Item no. 1888 600 150 and 1888 998 101

Fig. 1: clutch

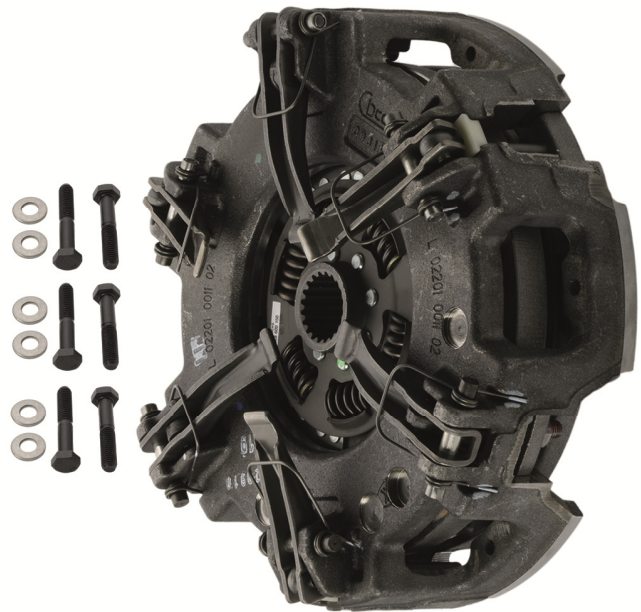
Clutches with ventilated clutch housing, torsion springs and sintered linings (item no. 1888 600 150 and 1888 998 101) will replace the clutches (item no. 1888 600 117, 1888 600 119 and 1888 634 006).

The clutch with ventilated housing can be fitted without having to modify the flywheel.
Six screws M8x1.25x45 will be supplied.
